Clause 162 D2.0 Comment Resolution

Howard Heck, Intel Corporation

IEEE P802.3ck Task Force, May 2021

comagenda_3ck_01_0521

dawe_01_042821, slide 11

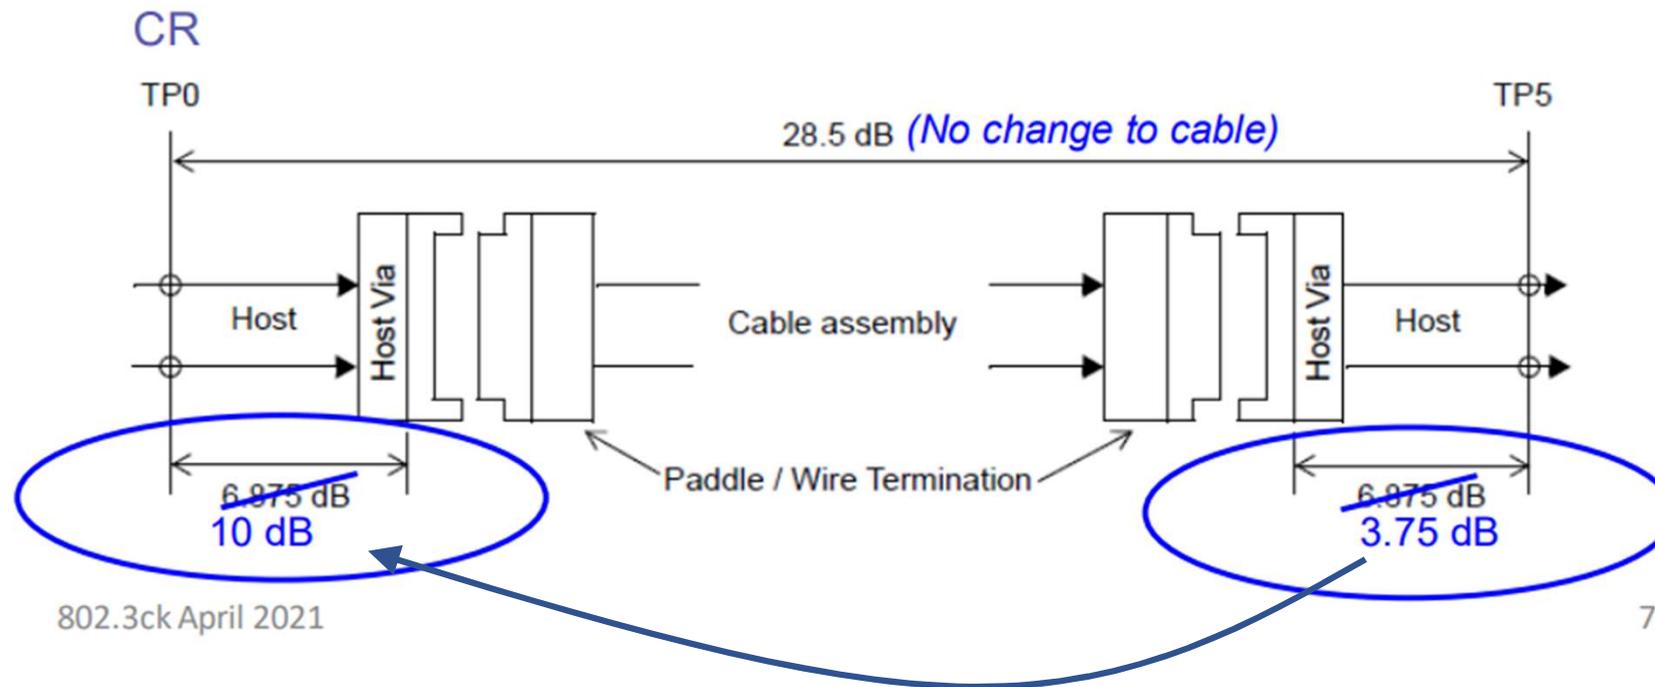
Comment 166, improve the CR loss allocations

- *Subclause 162.9.3 Page 154 Line 21* Type **TR**
- The draft loss budget wastes over 3 dB in nearly every case.
- The recommended maximum insertion loss allocation for the host traces plus BGA footprint and host connector footprint, of 6.875 dB, compares very poorly with C2M's host insertion loss up to 11.9 dB, making passive copper expensive and unattractive for a switch, while a full range of NICs can be made within only 3.75 dB. Server-switch links will get made with an asymmetric loss budget, so it would be better for the standard to regularise what will happen anyway. By the way, many server-switch links will be asymmetric anyway (different form factors at server and switch ends), and that's already allowed in this draft.
- This change would also benefit CR switch-switch links because the shortest ports would get credit for their low loss.

- As we have done for C2M, create two kinds of CR ports. Host loss allocations of 3.75 dB and 10 dB. Short can connect to short or long with same cable as today; long to long is not supported. Add entries in Clause 73 Auto-Negotiation to advertise short and long to the other end.

- In Table 162-10, provide separate limits for Linear fit pulse peak (min).
- In Table 162-14, provide separate rows for Test channel insertion loss: for testing the short host input the values for Test 2 are $10 - 6.875 = 3.125$ dB higher (26.75 dB and 27.75 dB), while for the long host input the values for Test 2 are $6.875 - 3.75 = 3.125$ dB lower (20.5 dB and 21.5 dB). No change needed for Test 1.

PROPOSED REJECT.

The suggested remedy would require two different CR port types. The suggested remedy does not provide a complete solution for the new port type.
